# El Dorado Hills Area Planning Advisory Committee

## **Montano Phase II Z15-0002 P15-0006 PD15-0004 S17-0015 Montano Sub Committee FEIR Response**

The El Dorado Hills Area Planning Advisory Committee formed a Subcommittee (EDH APAC Subcommittee) to study and review the Montano de El Dorado Phase 2 Z15-0002 P15-0006 PD15-0004 S17-0015 project. These are our public comments regarding the FEIR.

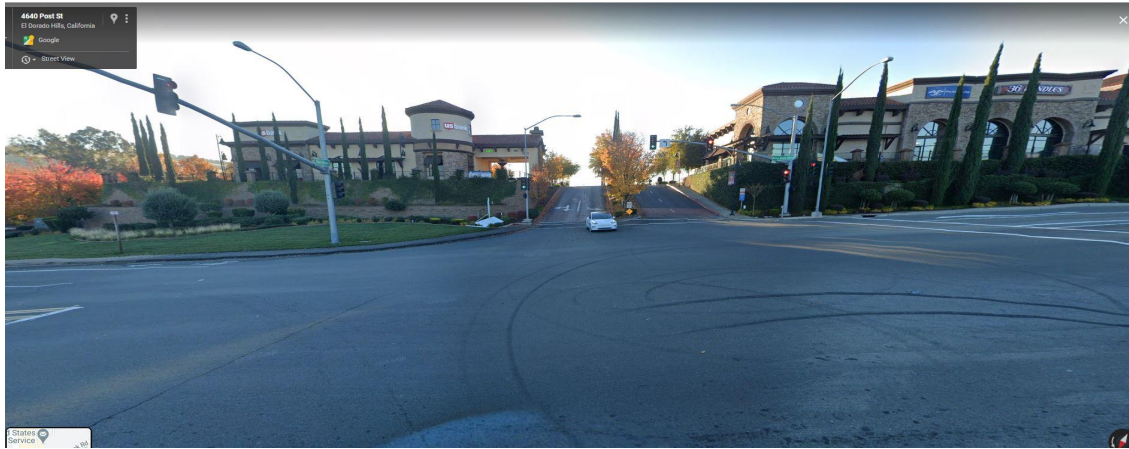
**O4-11** - This Response in the FEIR provides that despite the commenters' concerns that existing traffic does not comply with the existing posted prohibition of left turn movements exiting the eastern project driveway on White Rock Road, that:

It is observed that the County currently has numerous unfunded Capital Improvement Projects identified, and that a minor improvement such as this request for a median on White Rock Road be installed to augment the prohibition of left turns at this location on White Rock Road, if evaluated and considered "for potential future safety issues" would just be added to the unfunded CIP - effective mitigation of the circulation and safety concerns at this project site would be more appropriately addressed by including it as a condition of approval of this project.

*...the County will monitor this driveway for potential future safety issues.*

Post Street Parking Aisle Entrance - view to south

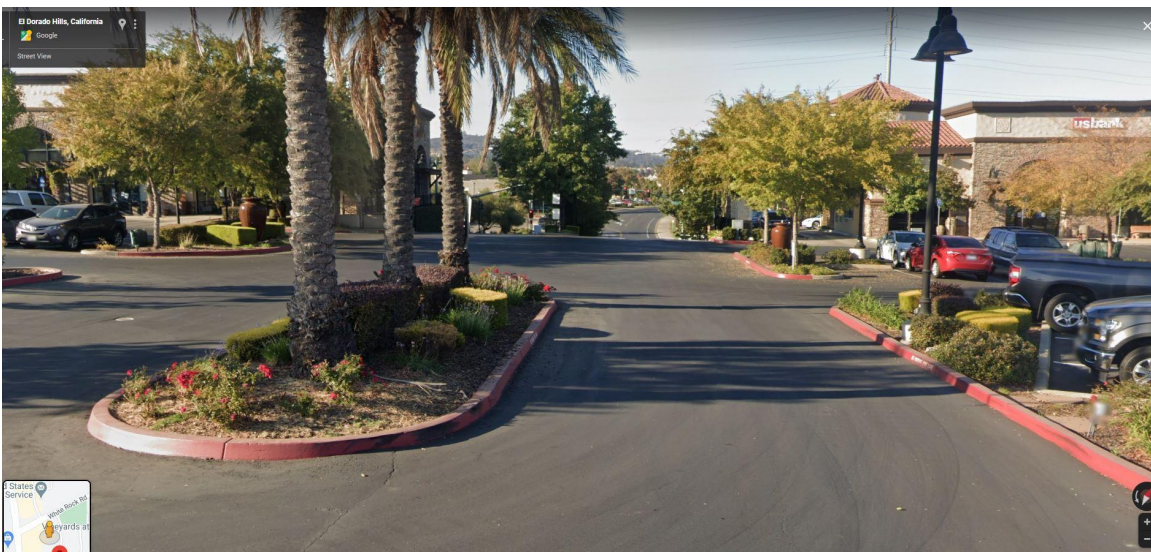
This project proposes extending Post Street through the project site as an additional roadway to mitigate potential traffic and circulation impacts - to provide a measure of circulation relief. However, both the existing Post Street to the north of the project in the Town Center East development, and the proposed extension of Post Street to the south through the project site, are private roadways. There are no possibilities for future circulation improvements of these private roadways if circulation conditions continue to evolve. The proposed Post Street extension from White Rock Road to Latrobe Road as represented in the project documents, appears to be nothing more than an interior parking lot connector roadway, with numerous parking aisles crossing the proposed roadway. If the proposed Post Street extension is to be considered an adequate mitigation of circulation impacts of the project, then the roadway should be designed to County Road Design Standards, and function as an actual part of the County Road network. As it exists currently along the proposed Post Street alignment inside the Phase 1 project parking lot, the drive aisle offers very poor sightlines. Designed road speeds would have to be well below 25MPH to operate safely. As such, a sub-25MPH roadway is not an effective circulation improvement to the transportation network in El Dorado Hills.
